MEMORANDUM

Subj: C.D. Landfill and Access Road to Naval Supply Center

Encl: (1) Plan View and Section of an Area at the C.D. Landfill.
(2) Letter of 20 Jan. 1989 from Dept. of Waste Management.

Re: CD Area Landfill, permit #286, Norfolk

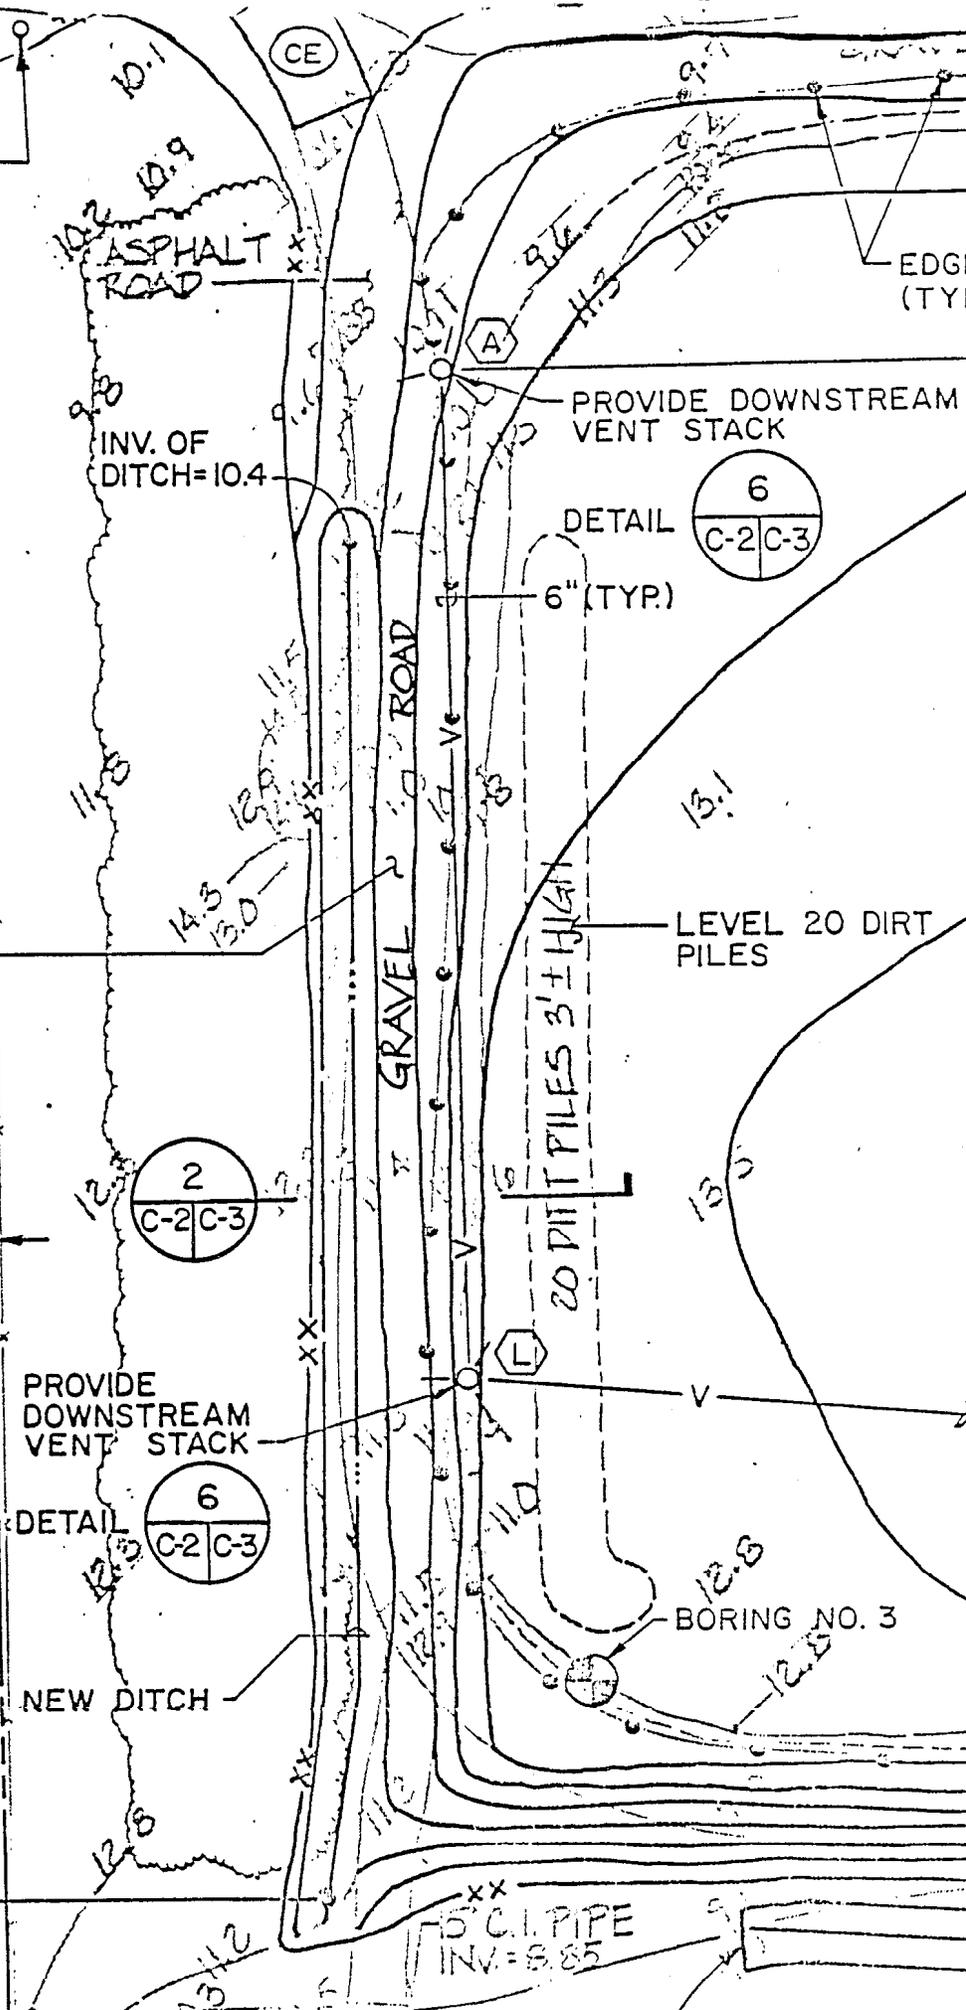
1. Confirming our discussions in ref. (a) the existing gravel road shown on enclosure (1) is located within the C.D. Landfill Closure Plan. This road is to be removed during the construction of the closure in accordance with the approved closure plan.

3. During ref. (a) upgrading the existing road was proposed. We strongly recommend that no roadwork be performed on the landfill without prior approval by the State Dept. of Waste Management. As discussed in ref. (b) it is unlikely that the state would approve continued use of the existing road without first capping the fill and providing drainage plans to divert runoff away from the landfill.
